Serial No. NA3-09-017R
Docket No. 52-017
COL/MWH

DOMINION VIRGINIA POWER
NORTH ANNA UNIT 3 COMBINED LICENSE APPLICATION
RESPONSE TO REQUEST FOR ADDITIONAL INFORMATION LETTER 036 (FSAR
CHAPTER 09)

**2.4.2 ITAAC FOR Plant Service Water System
(portion outside the scope of the certified design)**

Figure 9.2-1R Plant Service Water System Simplified Diagram

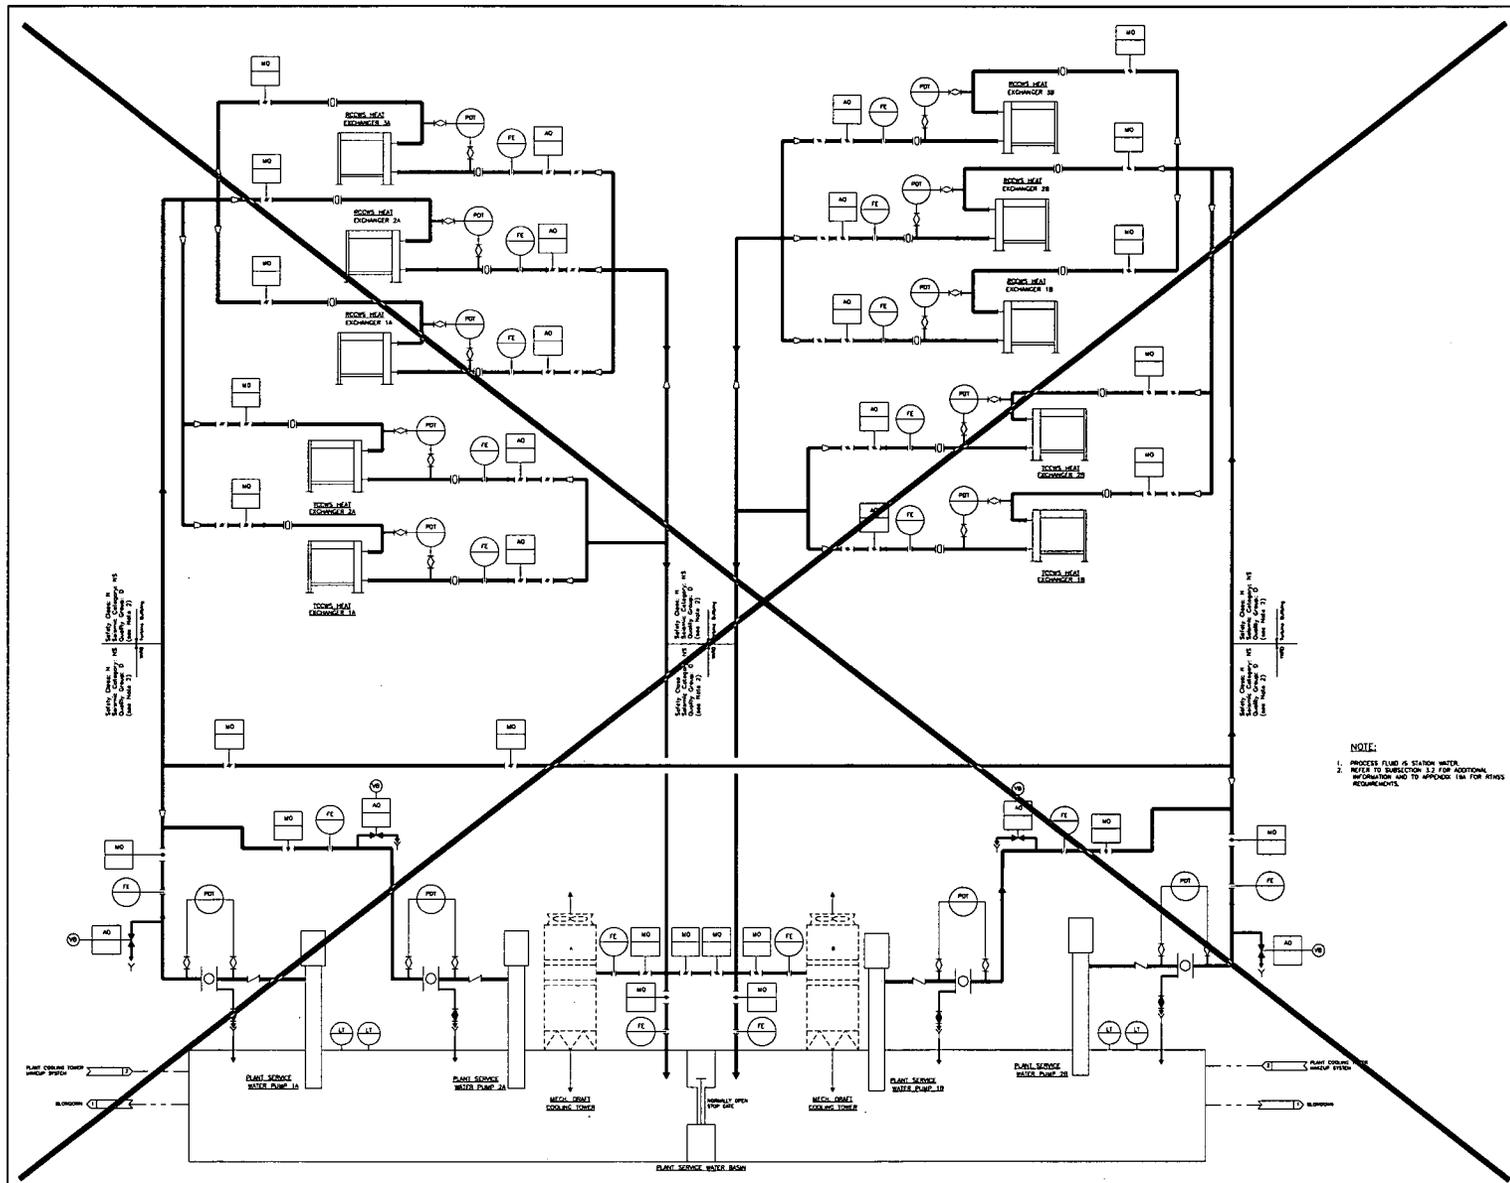
Reference RAI 9.2.1-05 (ID 363/1177) and Dominion response dated August 28, 2008. Tier 2 of the ESBWR DCD, Section 9.2.1.2, indicates that the heat rejection facilities are dependent upon actual site conditions and provides conceptual design information (CDI) for the standard plant design. FSAR Section 9.2.1.2 replaces the CDI but does not clearly differentiate between plant-specific and standard plant design information.

Please revise the FSAR Section 9.2.1.2 to clearly identify the plant-specific information that addresses the CDI identified in the ESBWR DCD.

FSAR Section 9.2.1.2, Table 9.2-201, and Figure 9.2-201 will be revised to clearly identify the plant-specific information that addresses CDI identified in the ESBWR DCD. The standard plant design information incorporated by reference will be removed from the text in Section 9.2.1.2 and clear demarcation will be provided for the NAPS CDI information in Table 9.2-201 and Figure 9.2-201.

FSAR Table 1.7-202, Table 1.8-203, FSAR Section 9.2.1.2, Table 9.2-201, and Figure 9.2-201 will be revised as indicated in the attached markup.
